Design Freeze Status

Flex-PLI-GTR Development Full Calibration Test Procedures

Comments addressed from Design Freeze meeting
February 20th 2008, JARI, Tsukuba, Japan
Update February 29th, 2008

SAE J2570

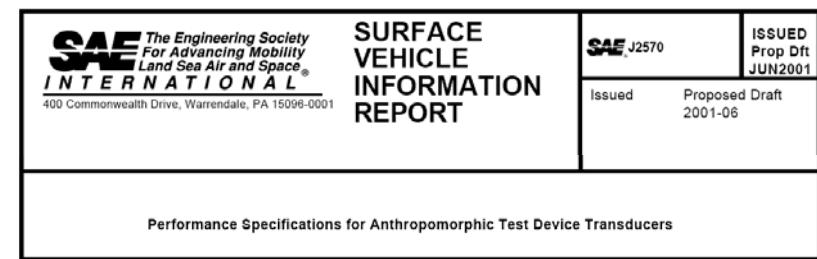
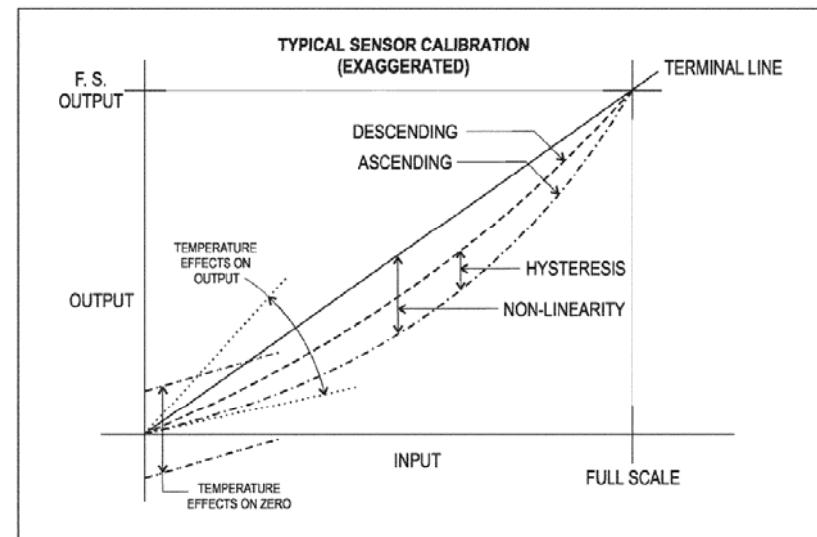
- SAE J2570 is not applicable to FLEX-PLI bone by definition
 - Max deflection < 0.254mm
- Relevant criteria
 - Hysteresis \leq 1% of full scale capacity
 - Non-linearity \leq 1% of full scale capacity
- These are design goals!
- May be difficult to meet due to flexible nature of the bone
- Little experience with high deflection!

Bone Calibration Analysis

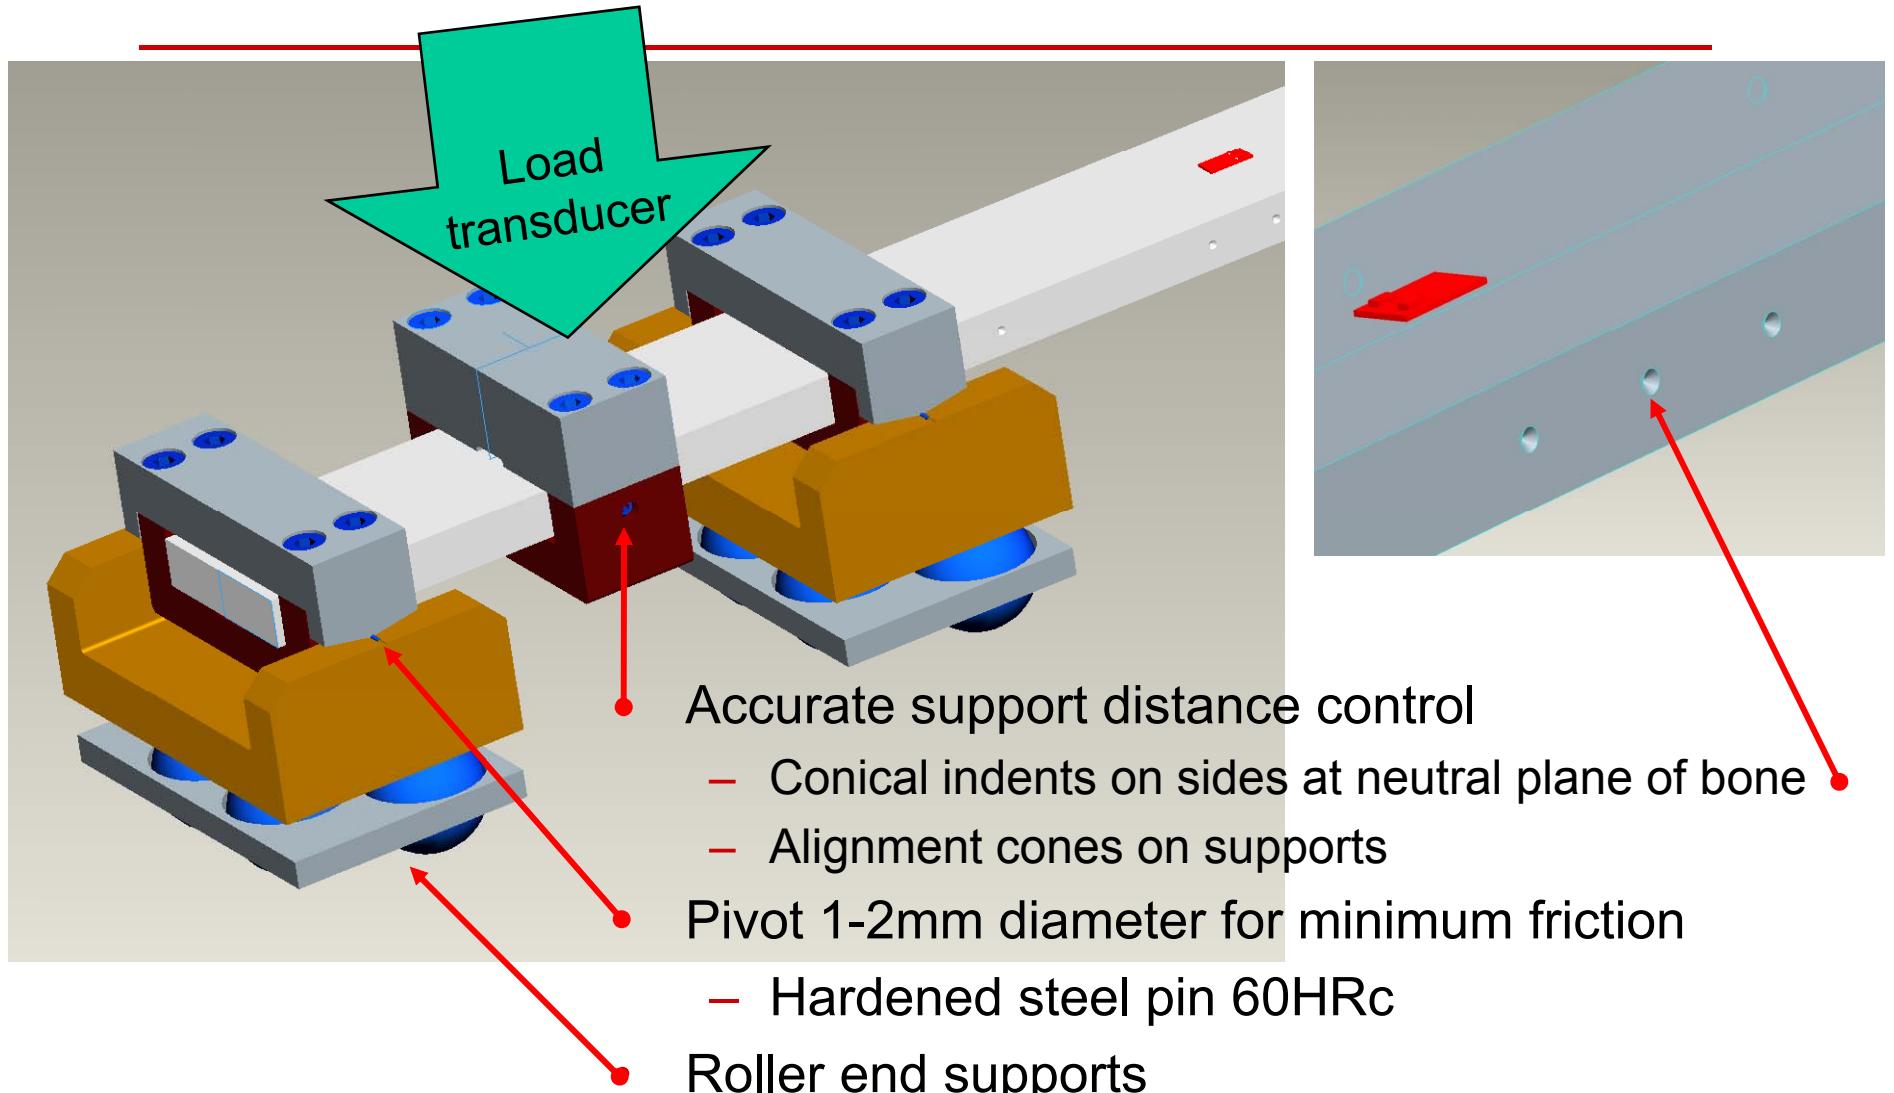
JARI Please check bone properties

Long Bone Assembly Calibration

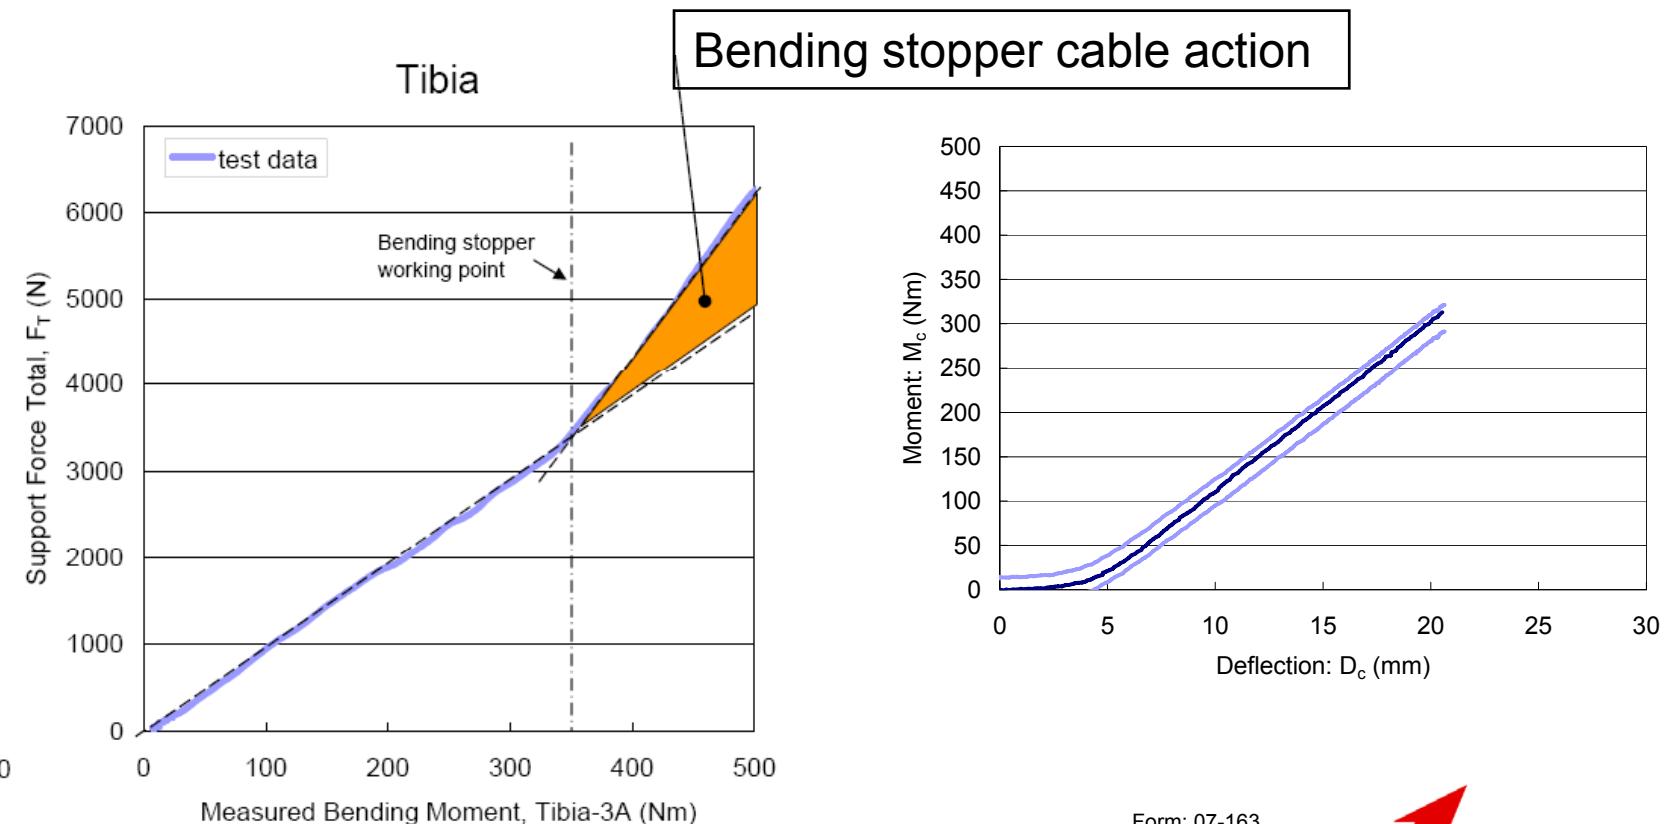
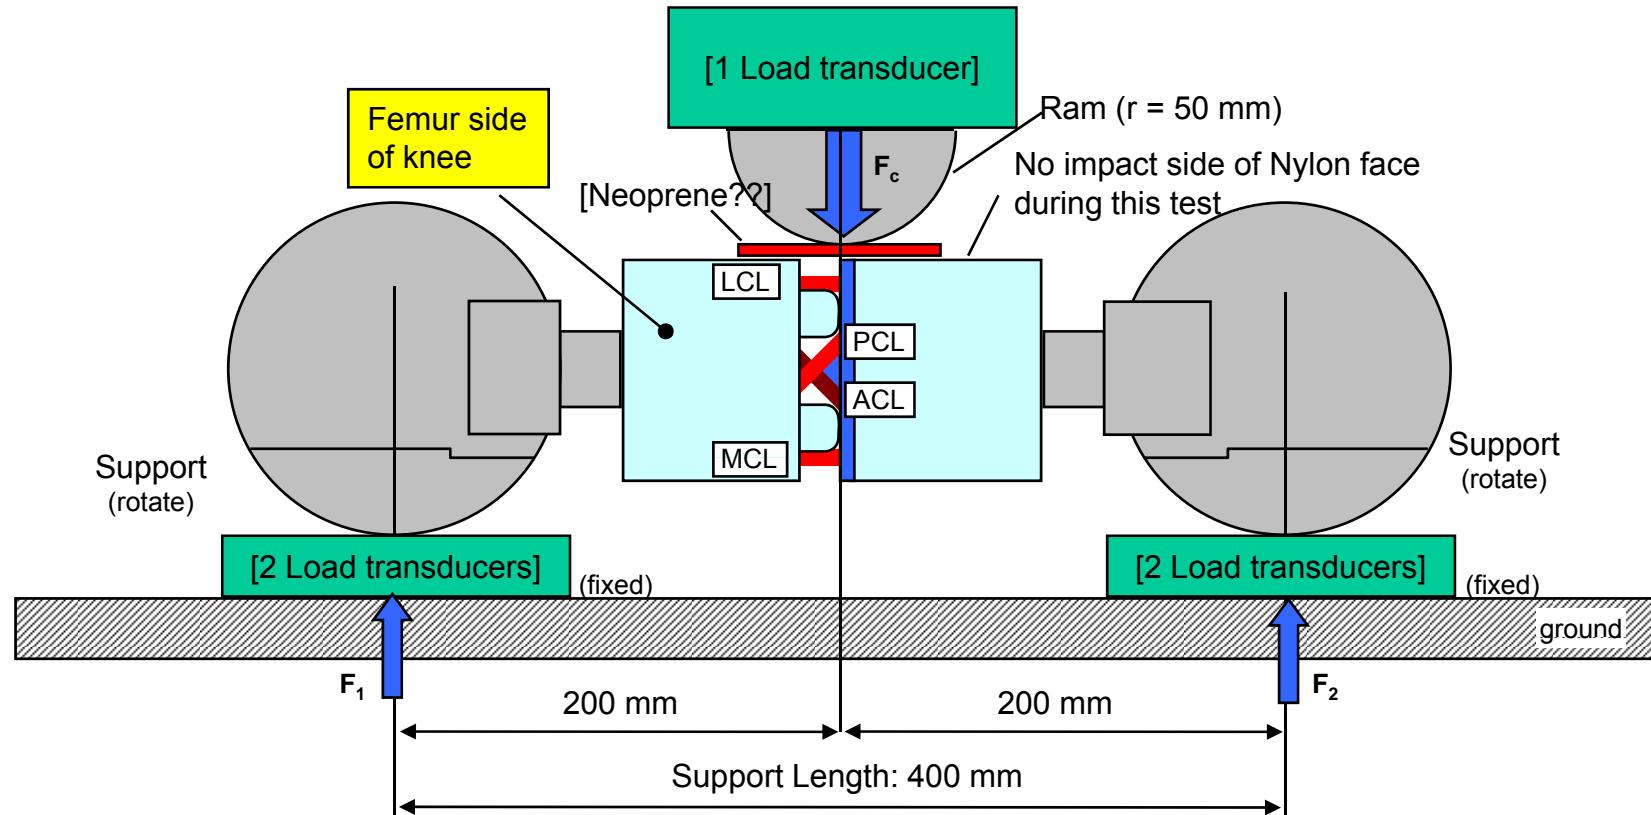
- Load up to IARV [300Nm] to ensure correct IARV measurement below bending stopper working point

Stopper material consistency test

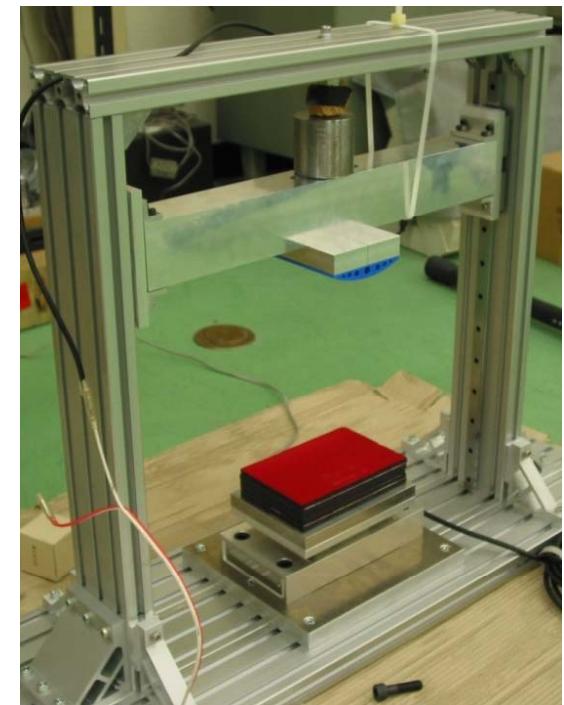
- Tibia acceleration may be dependent from two parameters
 - stopper material
 - tibia response
- To be able to identify problem in case of calibration failure: tibia or stopper material
- Need to have additional procedure for stopper material test
 - Control stopper material over extended time of loading/use
 - FTSS to make proposal for dynamic (drop?) test
